Technical Advisory Bulletin (TAB)

Bulletin #: TBBE1609A

Product: BERNINA E16

Subject: Hook Adapter Flange, P/N 34326

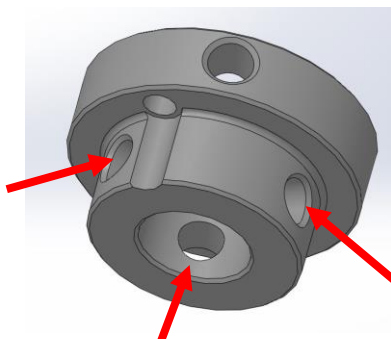
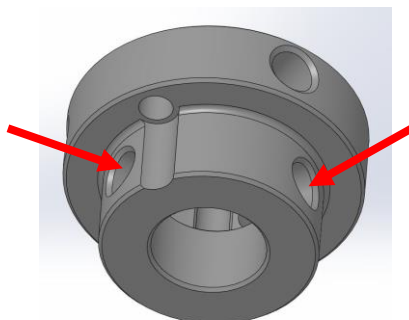
The production Hook Adapter Flange, P/N 34326, currently assembles to the bobbin shaft using (3) set screws as shown below. After these set screws are tightened, the hook can sometimes run eccentric and wobble as it rotates. This can have a direct effect on setting and maintaining hook timing and hook gap.

The new Hook Adapter Flange, P/N 34326, has been modified and now has (2) set screws instead of (3) as shown below. Tightening only 2 set screws has been found to minimize hook eccentricity and wobble, thereby maintaining consistent hook timing and hook gap settings during sewing.

- If a technician experiences excessive hook eccentricity or wobble, they can try two things.
 - One, reset hook timing and only tighten 2 of the 3 set screws that hold the Hook Adapter Flange to the bobbin shaft. The third set screw should be removed and discarded.
 - Two, they can order the new Hook Adapter Flange having only 2 set screw locations and set hook timing as originally instructed.
- NOTE: The set screw locations on the new Hook Adapter Flange are now located so that all set screws can be accessed and tightened when setting both hook timing and hook gap as shown below. No longer does the hook need to be rotated when tightening all the set screws.
